CITY OF WEST DES MOINES
STAFF REPORT COMMUNICATION

ITEM: Valley Southwoods, 625 S. 35th Street – Approve Major Modification to Site Plan to allow approximately 42,000-sq. ft. of building additions – West Des Moines Community Schools – MaM-004976-2022

Resolution: Approval of Major Modification to Site Plan

EXTERIOR ELEVATIONS

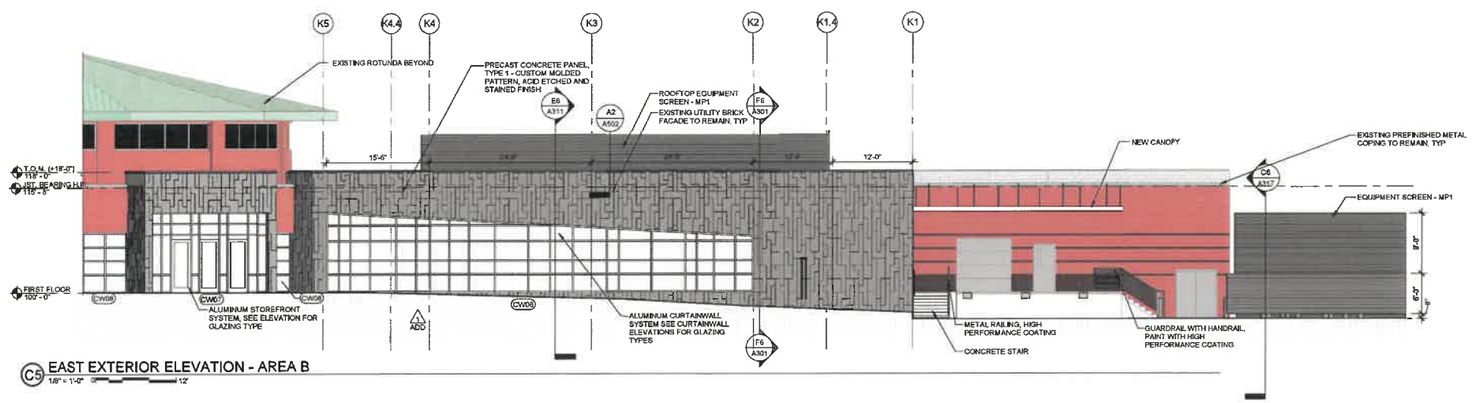
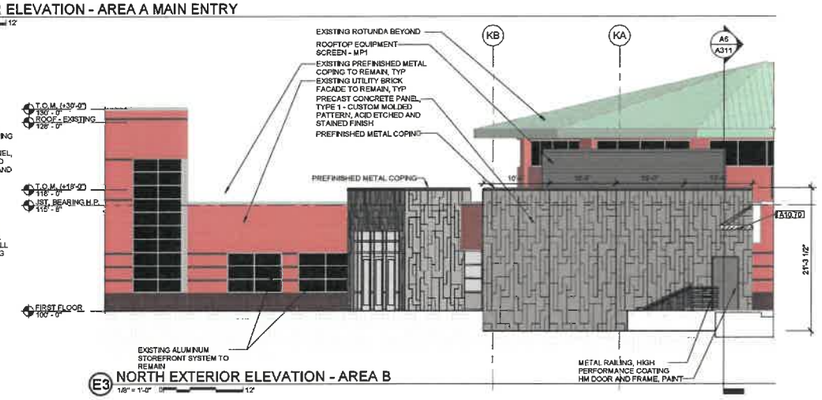
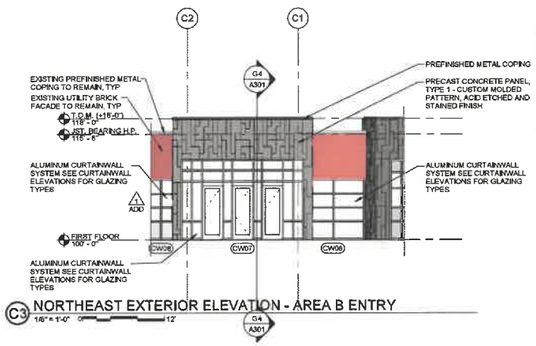
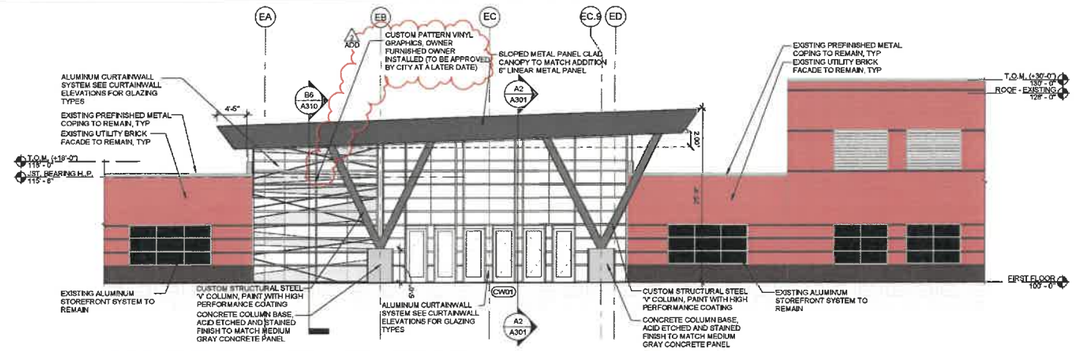
- *Architecture.*
  - Building Design: The proposed modifications include a large addition on the south side of the building which includes the outdoor use space, a new entry canopy and vestibule addition at the main entry, and a small addition for the culinary arts at the rear courtyard on the north side of the building. The additions provide a new architectural design intent for the overall building than that of the existing traditional brick school building. The new additions are proposed to be constructed of concrete panels in a two-tone color pallet with various molded and revel patterns as shown on the enclosed proposed building elevations. Secondary cladding materials for the additions include translucent wall panels, aluminum curtail walls, metal screen walls, a metal entry canopy, and metal coping and trim details. Also included on the main (south addition) is the inclusion of five overhead doors (two on the west façade, two on the south façade into the outdoor use space, and one on the east elevation).

Staff is not opposed to a more unique design element for the new building additions as desired by the applicant, however staff has suggested that some design elements should be compatible from the existing building design to the new to provide an element of continuity of design from the old to the new. This could include elements such as massing, materials, color, design details, etc. Staff feels there is still a disconnect between the two design intents.

Staff still would like to see better cohesiveness between the new and existing elements of the building. Staff understands that the roof and windows may be changed out at some point in the future to compliment this proposed new design intent however, when this may happen and the tracking to confirm this will happen at the time of those projects is difficult from the city standpoint. Therefore, staff still has a concern for the variation in design from the existing building. The applicant is unwilling to pursue further discussions on the building design with City staff. Therefore, staff is requesting input from the Plan and Zoning Commission on the concerns noted above and recommends a condition of approval that prior to issuance of any building permit the applicant continue to work with Staff, based upon direct input from the Plan and Zoning Commission, to find design solutions to achieve better cohesiveness between the addition and existing building.

highly active spaces. The colors compliment the building without trying to replicate the original building. Studies issued since the construction of the original building, emphasize the value and importance of natural light in the classroom. The translucent wall panel system was selected to provide natural light, while limiting glare to enhance the quality of learning environment in the technical lab spaces.

The Owner has indicated they will change the green metal coping and metal roofing of the existing portions of the building to match the new addition once the materials have exceeded their useful life. The Owner also indicated they will change the glazing from the existing dark-tinted to compliment the glazing in the new addition once the windows need to be replaced.
